UNITED STATES PATENT AND TRADEMARK OFFICE

10/510,351

Office Action Summary	Application No.		Applicant(s)	
	10/510,351		BODNAR, ERNEST R.	
	Examiner		Art Unit	
	CHRISTINE T. CAJILIG		3633

Title : STEEL STUD WITH OPENINGS AND EDGE FORMATIONS
AND METHOD

Bodnar '625

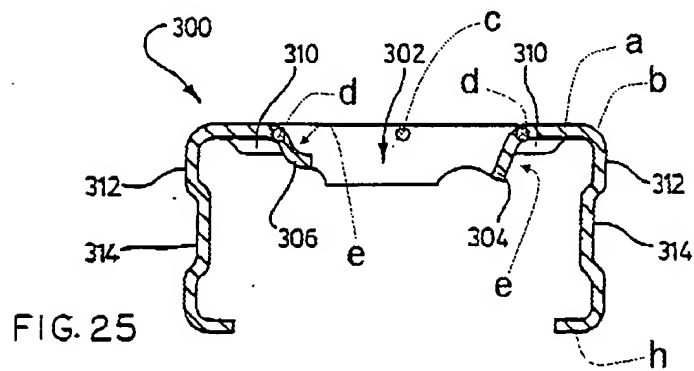
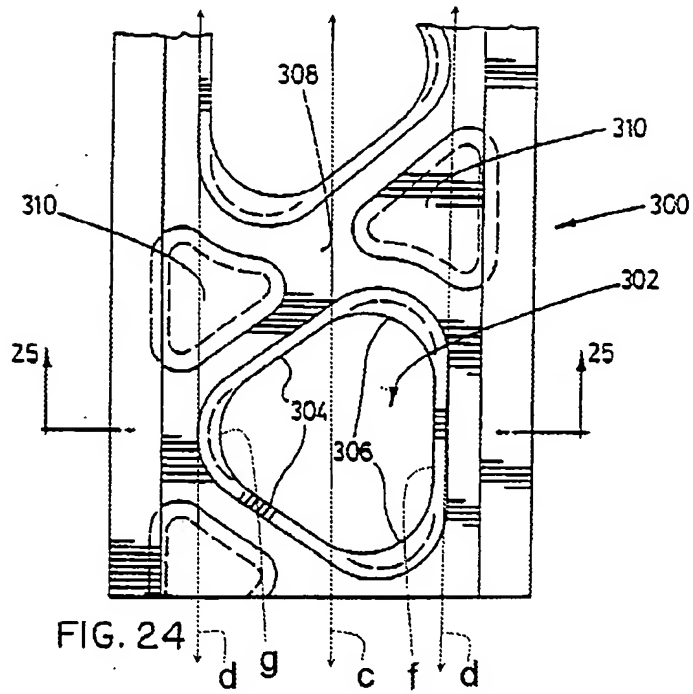
Regarding claim 1, Bodnar '625 in Figures 24-25 discloses a steel member for use in supporting structures and having reduced heat transfer characteristics as compared with solid web studs, and characterized by a web (a) defining side edges and an axis (c); a flange (312) on at least one side edge; openings (302) through said web at spaced intervals therealong, of predetermined size and profile, at least a side portion (304, 306) of said web being removed from said opening and remaining attached integrally to said web, and being bent away from said web along axes (d) parallel to said web axis (c).

Regarding claim 3, Bodnar '625 discloses the structure discussed above and further discloses that said side portion (304, 306) defines a channel shape (e) extending along an axis parallel to said web axis.

Regarding claim 4, Bodnar '625 discloses the structure discussed above and further discloses that said openings (302) are of a shape defining a linear side edge (f), and an arcuate side edge (g), said side portion (304, 306) of said web being integral with said linear side edge (f).

Regarding claim 5, Bodnar '625 discloses the structure discussed above and further discloses that there are two said flanges (312) one on each side of said web, being formed at normal to said web, and lips (h) formed along said flanges and normal to said flanges.

Regarding claim 6, Bodnar '625 discloses the structure discussed above and further discloses that openings (302) are arranged in an alternating orientation and struts (308) are defined between said openings, said struts extending diagonally across said member.

Regarding claim 26, Bodnar '625 in Figures 24-25 discloses a steel member having a web (a), side edges, and a flange (312) along at least one said side edge and openings (302) through said web wherein said openings (302) are formed in said web at spaced intervals therealong, with one of said openings leaving a side portion of metal attached to said web forming an edge flange (304, 306) along said at least one side edge of said web and forming said side portion out of the plane of said web wherein said side portion is bent along bend lines (d) parallel to the web axis (c). Therefore, the method steps set forth in claim 26 of forming the steel member with the above said structure and bending side portions would have been an obvious if not inherent method of making the steel member having the same structure.

Folsom '781

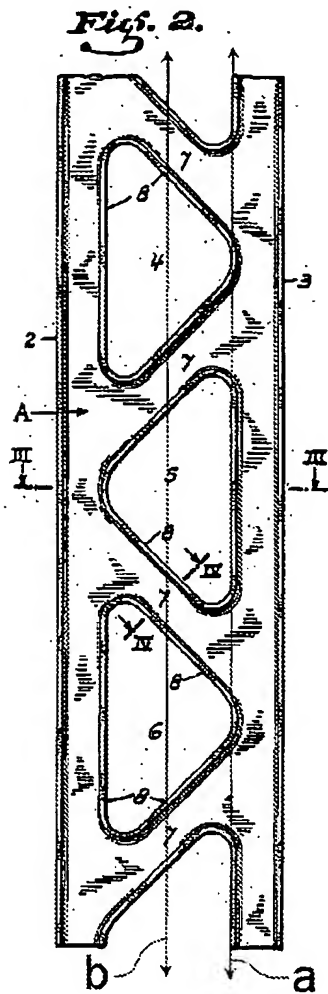
Regarding claim 1, Folsom '781 in Figures 1 and 2 discloses a metal member for use in supporting structures and having reduced heat transfer characteristics as

compared with solid web studs, and characterized by a web (A) defining side edges and an axis (b); a flange (3) on at least one side edge; openings (4-6) through said web at spaced intervals therealong, of predetermined size and profile, at least a side portion (8) of said web being removed from said opening and remaining attached integrally to said web, and being bent away from said web along axes (a) parallel to said web axis (b), but does not disclose that the member is steel. However, it would have been obvious to one having ordinary skill in the art at the time of invention to use steel, since it has been held to be within the general skill of a worker in the art to select a known material on the basis of its suitability for the intended use as a matter of obvious design choice. *In re Leshin*, 227 F.2d 197, 125 USPQ 416 (CCPA 1960)

Regarding claim 6, Folsom '781 discloses the structure discussed above and further discloses that said openings (406) are arranged in an alternating orientation and struts (7) are defined between said openings, said struts extending diagonally across said member.

Regarding claim 26, Folsom '781 discloses a steel member having a web (A), side edges, and a flange (3) along at least one said side edge and openings (4-6) through said web wherein said openings (4-6) are formed in said web at spaced intervals therealong, with one of said openings leaving a side portion of metal attached to said web forming an edge flange (8) along said at least one side edge of said web and forming said side portion out of the plane of said web wherein said side portion is bent along bend lines (a) parallel to the web axis (b). Therefore, the method steps set forth in claim 26 of forming the steel member with the above said structure and bending

Regarding claim 7, Folsom '781 discloses the structure discussed above, but does not disclose openings formed in said web at opposite ends of each said strut to restrict heat transfer through said member. However, Schnitzer '871 discloses a steel having opening (42) formed in a web (22) at opposite ends of each strut (24) to provide a light weight structural member. Therefore, it would have been obvious to a person having ordinary skill in the art at the time of the Applicant's invention to modify the structure of Folsom '781 to have holes on opposite ends of each strut as taught by Schnitzer '871 to provide an even more lightweight structure.

Regarding claim 28, Folsom '781 discloses the method discussed above, and further discloses struts (7) formed extending across said web between said openings and forming slots, but does not disclose slots in said web adjacent each end of each said strut. However, Schnitzer '871 discloses a steel having slots (42) formed in a web (22) adjacent each ends of each strut (24) to provide a light weight structural member. Therefore, it would have been obvious to a person having ordinary skill in the art at the time of the Applicant's invention to modify the structure of Folsom '781 to have slots on opposite ends of each strut as taught by Schnitzer '871 to provide an even more

Rafter '384

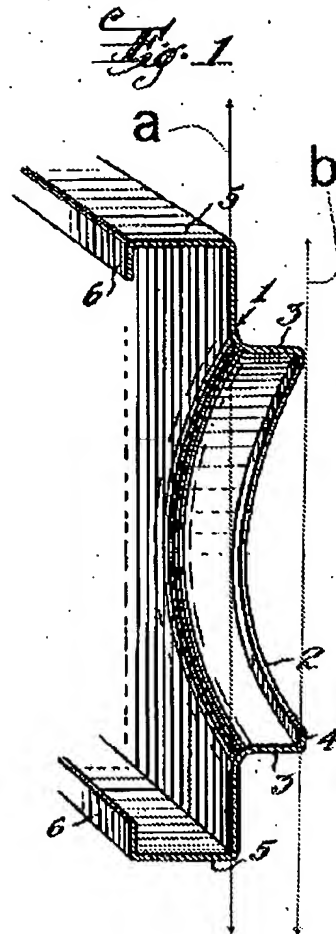
Regarding claim 1, Rafter '384 in Figure 1 discloses a metal member for use in supporting structures and having reduced heat transfer characteristics as compared with solid web studs, and characterized by a web (1) defining side edges and an axis (a); a flange (5) on at least one side edge; openings (2) through said web at spaced intervals therealong, of predetermined size and profile, at least a side portion (3, 4) of said web being removed from said opening and remaining attached integrally to said web, and being bent away from said web along axes (b) parallel to said web axis (a), but does not disclose that the member is steel. However, it would have been obvious to one having ordinary skill in the art at the time of invention to use steel, since it has been held to be within the general skill of a worker in the art to select a known material on the basis of its suitability for the intended use as a matter of obvious design choice. *In re Leshin*, 227 F.2d 197, 125 USPQ 416 (CCPA 1960)

Regarding claim 3, Rafter '384 discloses the structure discussed above and further discloses that said side portion (3, 4) defines a channel shape (created by 3 and 4) extending along an axis (between axes and b) parallel to said web axis.
